## **FUL/2022/0056 - Land off Crab Apple Lane, Haddiscoe, Norfolk, NR14 6SJ**

2. These following submissions made on our Client's behalf are to address uncertainties arising from the 100m buffer zone between the excavation boundary and sensitive receptors (to protect those sensitive receptors from dust, noise, and air pollution).

<p>NottoScale</p>	Drawing Title SENSITIVE RECEPTORS AREAS	
	Drawing Number HQ/AH/AS001	
DATE: 21/03/24		DRAWN: AH
CHECKED: DP		REV:

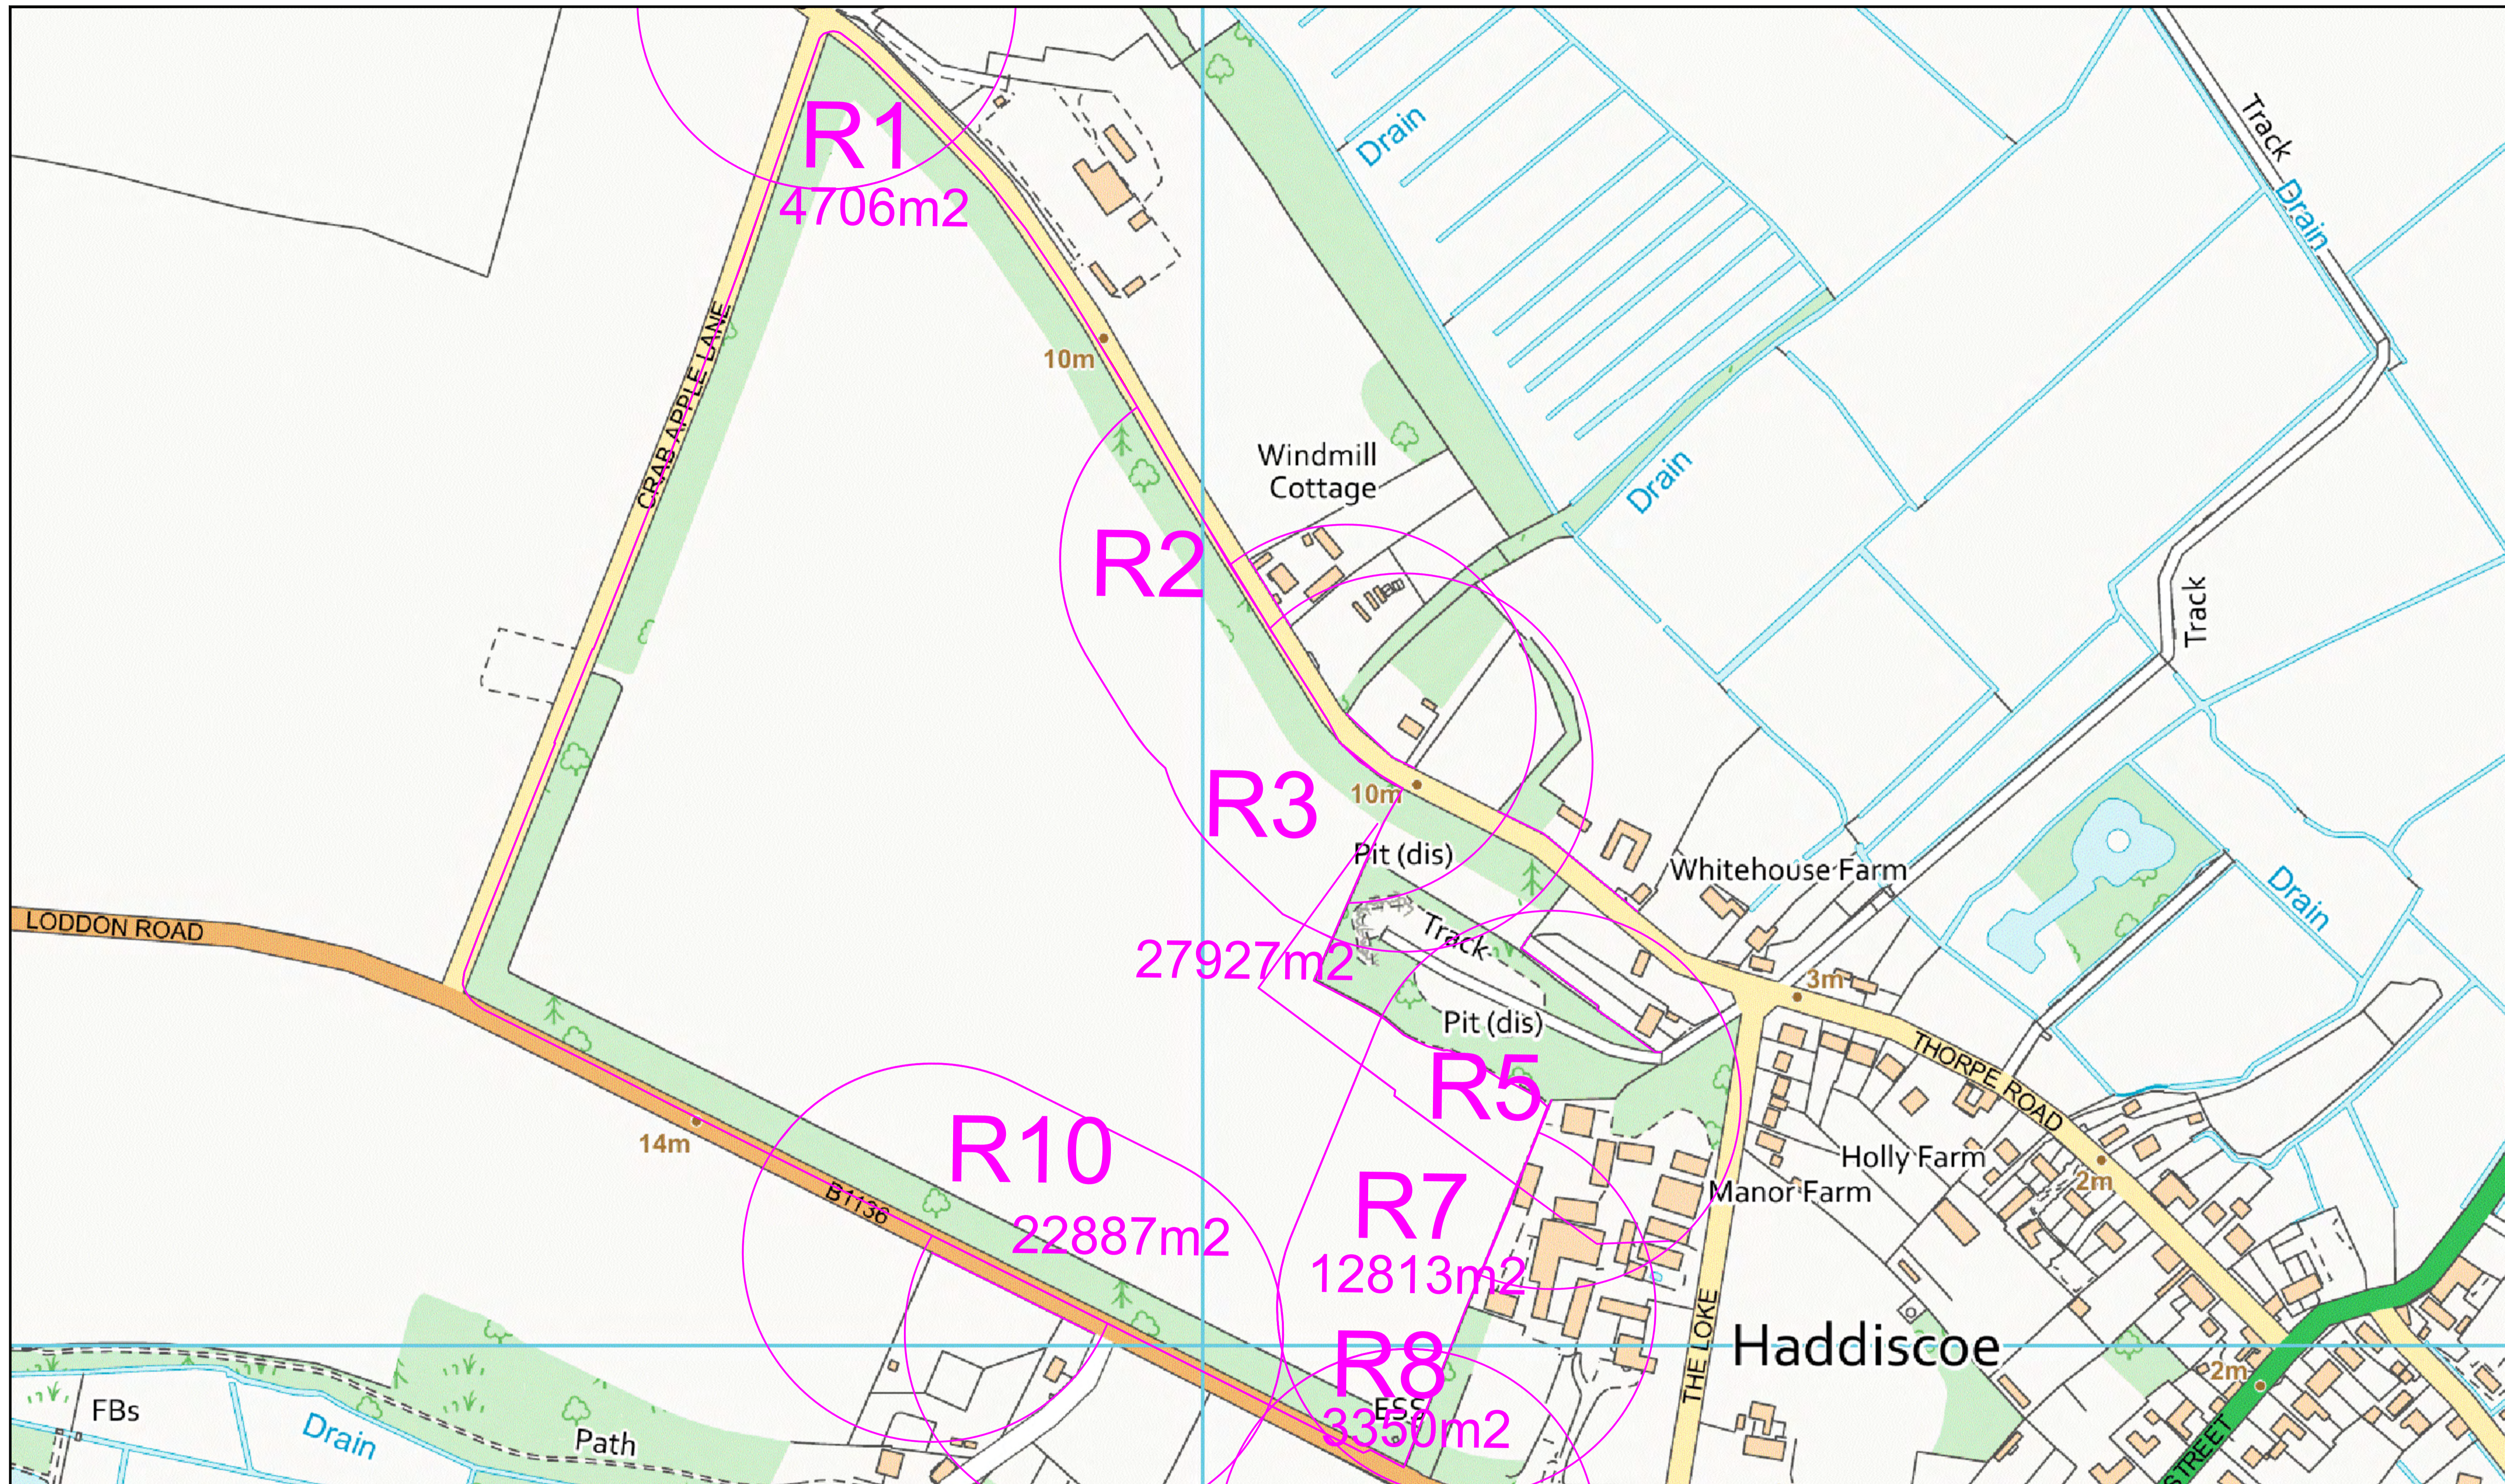
- iii) Our Clients have commissioned Hume Engineering to produce a plan showing an accurate mapping of 100m from 7 of the closest residential sensitive receptors identified in the Environmental Statement, using the property red line boundaries to include the entirety of the property (house and garden). When this plan is compared side by side with the amended excavation boundary in the map provided by the applicant (in Addendum B to their Regulation 25 response) it is clear that the excavation area is still within 100m of the boundaries of some of the sensitive residential receptors, and therefore falls short of the applicant's commitment.

The Stopit2 Association has contracted the services of Hume Engineering and Development Ltd to plot an accurate coordinated plan of the residential sensitive receptors listed by the developer (Breedons) within their Air Quality document ES V2 Chapter 10 Air Quality and Dust Haddiscoe and the 100m excavation boundary stand-off from the boundaries of the residential sensitive receptors in regards to the planning application 2022/0056.

Norfolk County Council have stated within min25 that the excavation phases should be set back a minimum 100m to Sensitive Receptors boundaries.
